David Matthews-Lane
27th January 2022

RE: Additional Information to DA2021/2033 for the construction of Secondary Dwelling at 18 Bambara Road, Frenchs Forest

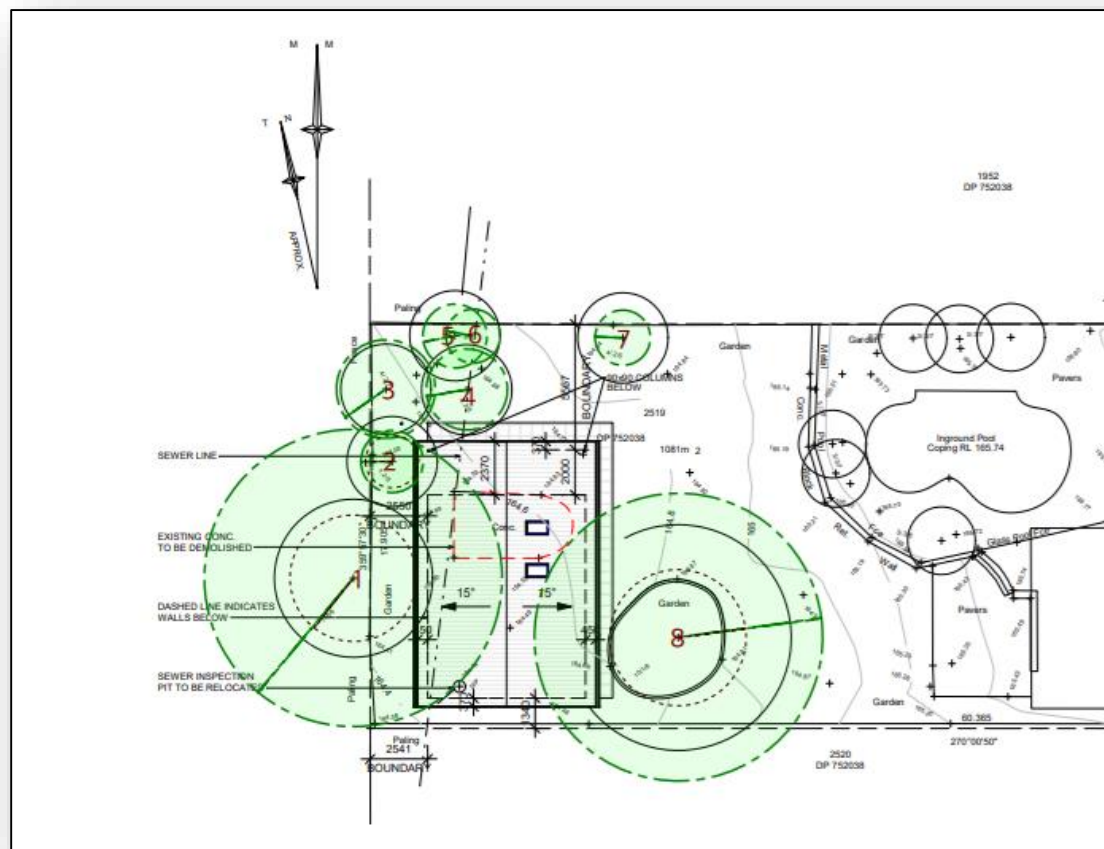
- 1) Impact on Trees
- 2) Stormwater
- 3) Rear Setback

As detailed in our DA submission, we wish to retain all trees on the site and have specifically selected the location of the Secondary Dwelling to avoid the need for any to be removed and to make use of those trees on the site to make the Secondary Dwelling fit in with the surrounds.

In short, none of the SRZs of the trees are impacted and in fact the location of the Secondary Dwelling in between the two largest trees (T1 and T8 in the Report) means that the location 2.5m from the rear boundary ensures the best location for avoiding the SRZs of either T1 or T8 as the diagram page 33 illustrates. It is the recommendation of the Arborist that with appropriate protective measures the trees should be retained and we agree.

If the footprint were to move further from the rear boundary and increase the rear setback, the SRZ of the Fig Tree (T8) would be impacted. Whilst this Fig Tree is not a protected species, we are keen to retain it as it provides valuable shade in our garden, feeds the native fruit bats and will provide some shade for the secondary dwelling.
